BOARD ACTION REPORT – APPEALABLE ITEM

Project Name: 100 Gleason (2020-029)
Project Location: 100 Gleason Street
Request: Class II Site Plan Modification
Board: Site Plan Review and Appearance Board
Meeting Date: December 11, 2019
Board Vote: Approved on a 5-2 vote

TO: Site Plan Review and Appearance Board (SPRAB)
FROM: Anthea Gianniotis, Development Services Director
THROUGH: Scott Pape, Principal Planner
DATE: December 3, 2019
SUBJECT: Class II Site Plan Modification for 100 Gleason Street (2020-029)

SITE PLAN REVIEW AND APPEARANCE BOARD STAFF REPORT

Scale: 3/16"=1'-0"

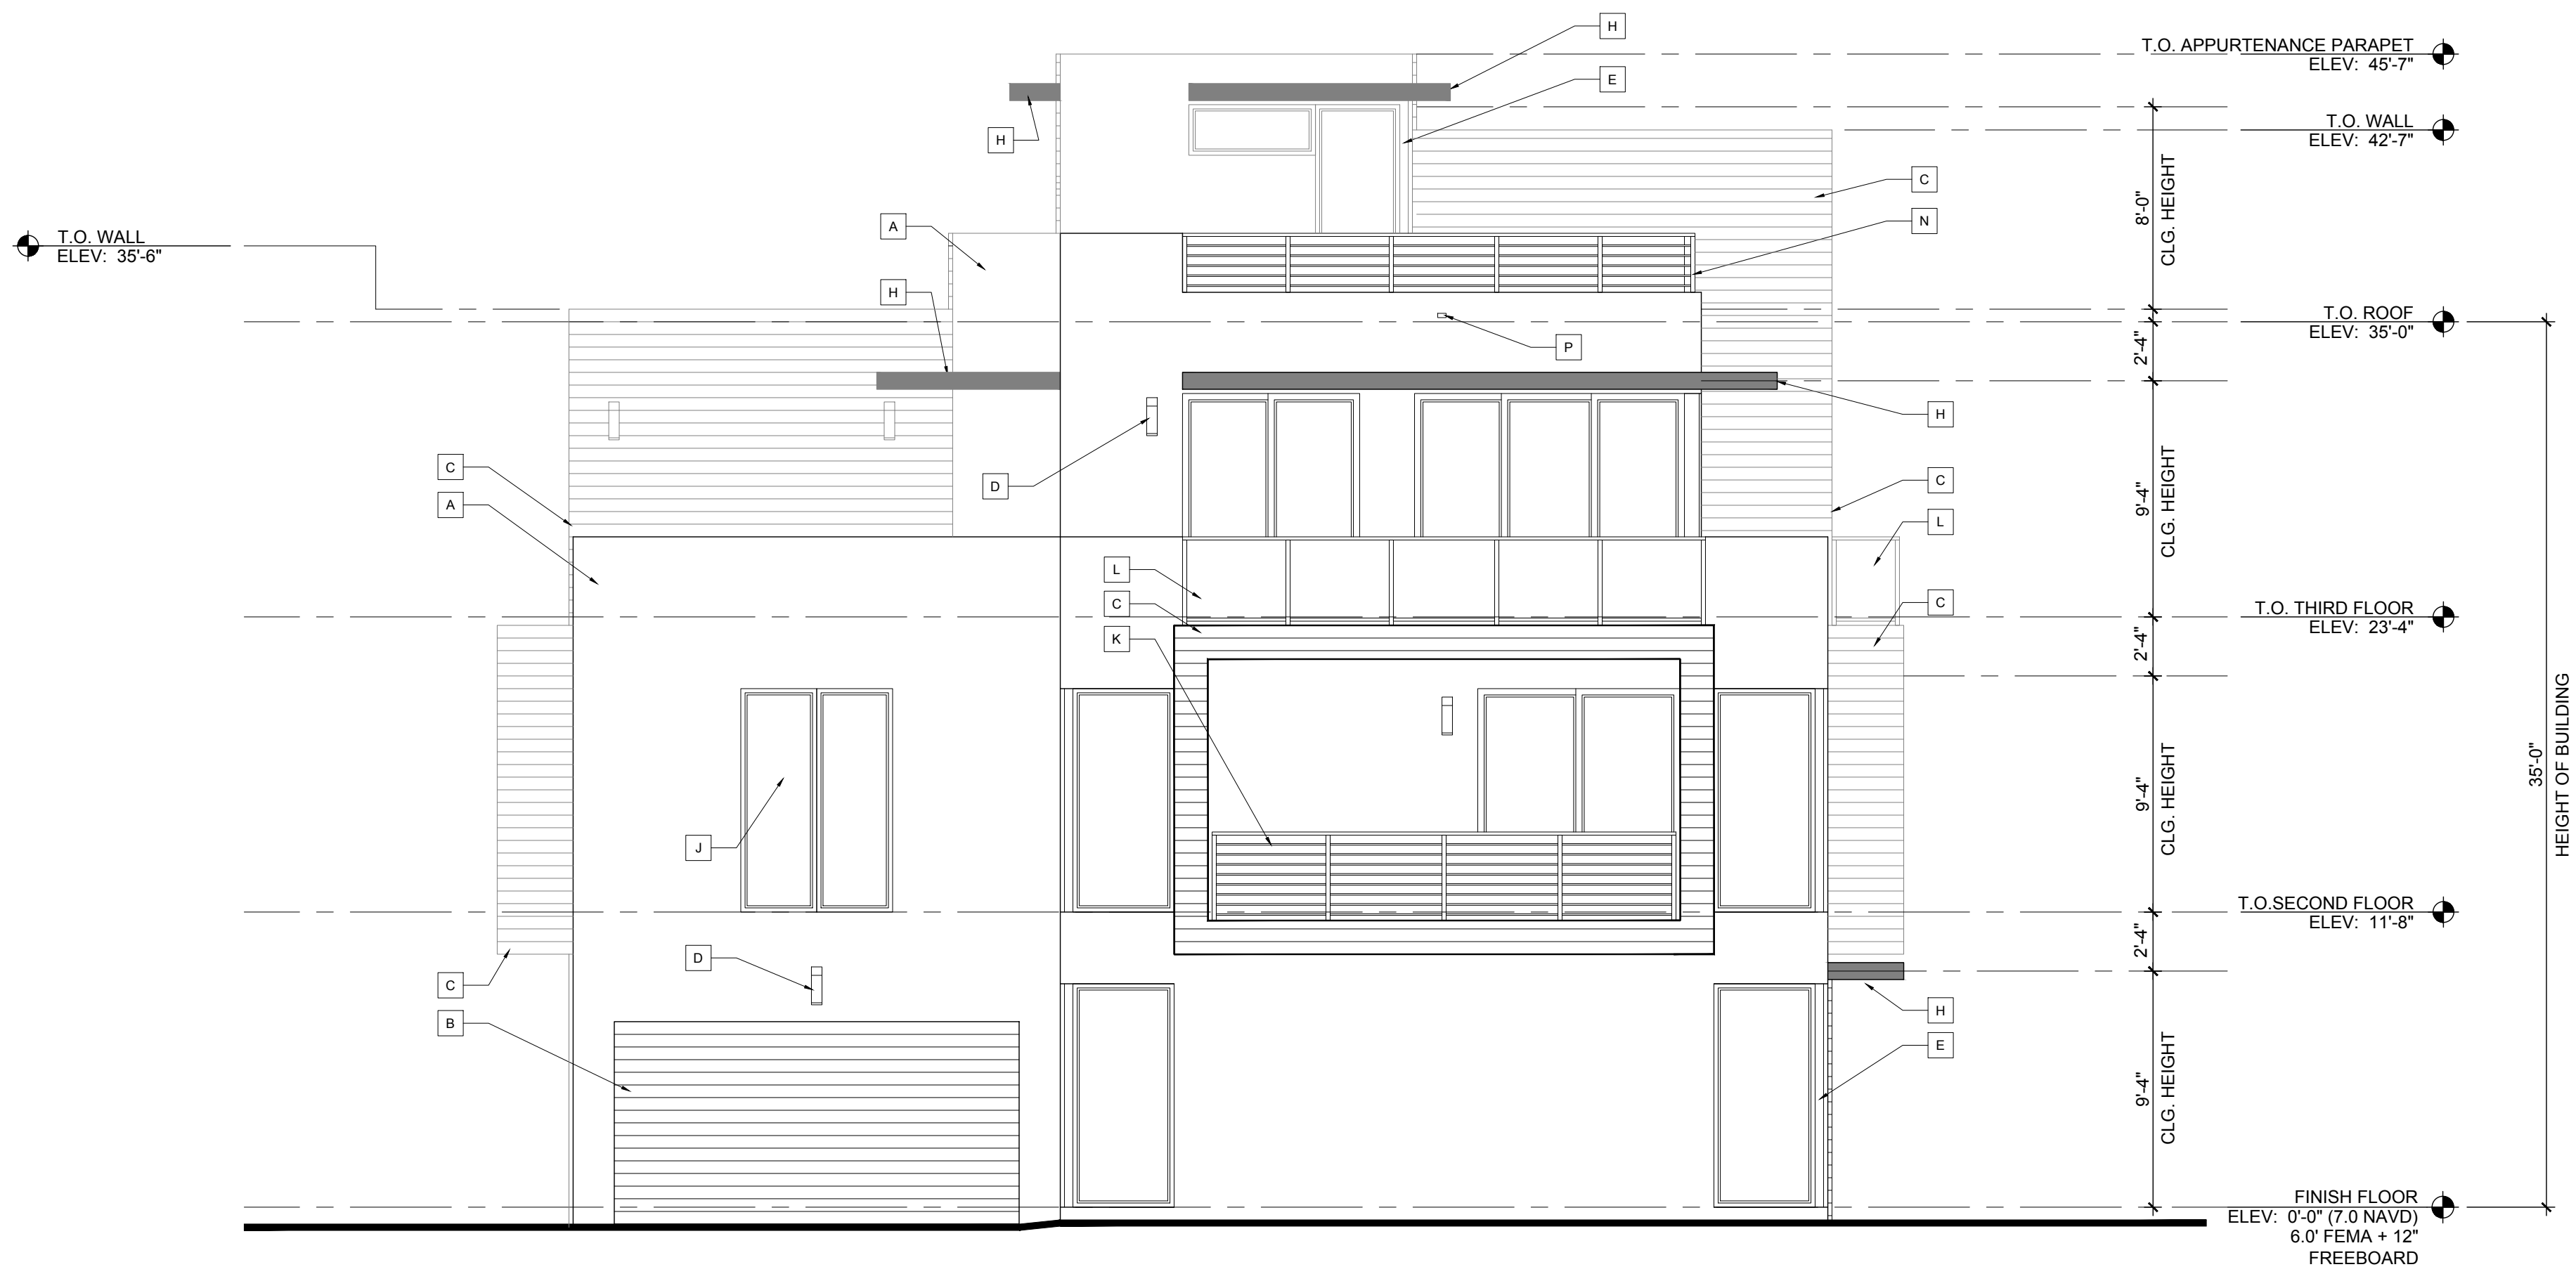
The Applicant has resubmitted plans that have the following changes in regard to the appurtenance.

- Appurtenance floor area reduced from 230 sf to 195 sf per unit.
- Appurtenance height reduced from 12 feet to 10 feet in height.
- Air Conditioner mechanicals relocated from within the appurtenance.
- Appurtenance setback increased by 4.25 feet along the western façade.
- Buttress stopped at the top of the Appurtenance roof parapet.

100 GLEASON APPURTENANCE LOCATION TO ADJACENT STRUCTURES

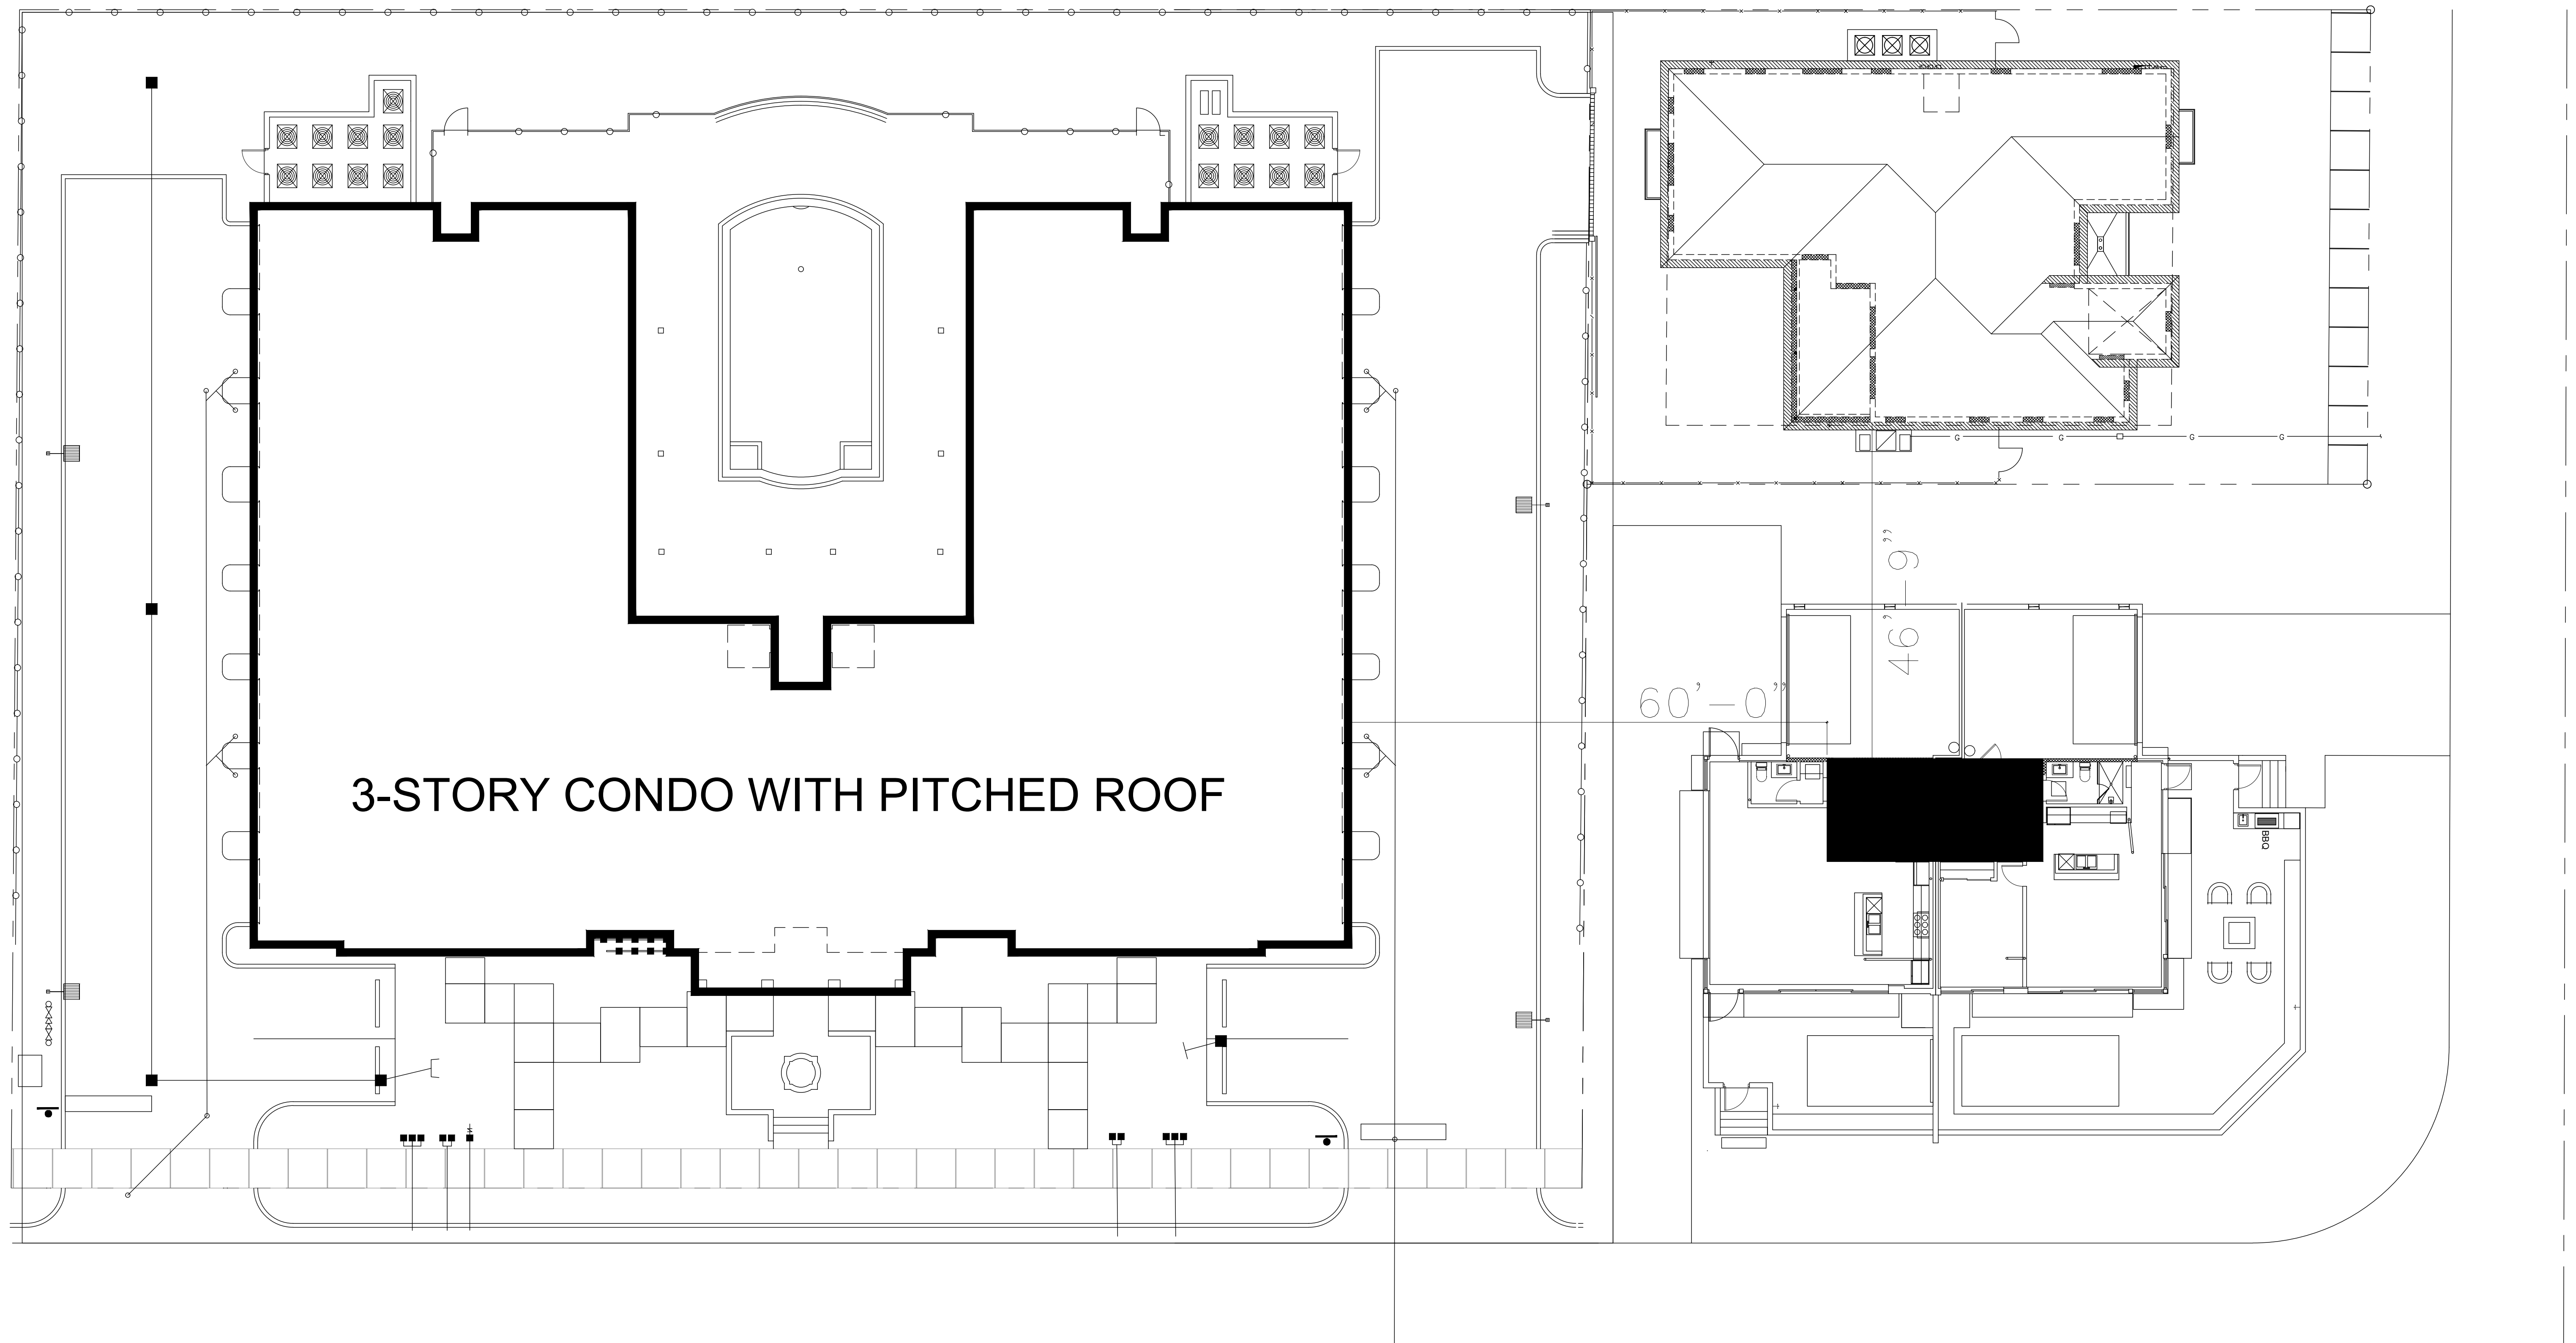
APPURTENANCE FLOOR AREA REDUCED TO BARE MINIMUM 195 SQ. FT. PER UNIT
APPURTENANCE HEIGHT REDUCED TO BARE MINIMUM 10'-0"
AIR CONDITIONER MOVED TO 3RD FLOOR
EYE BROWS REDUCED 12"
SETBACK TO WEST INCREASED BY 4'-3" TO 46'-9"
BUTTRESS STOPPED AT TOP OF PARAPET
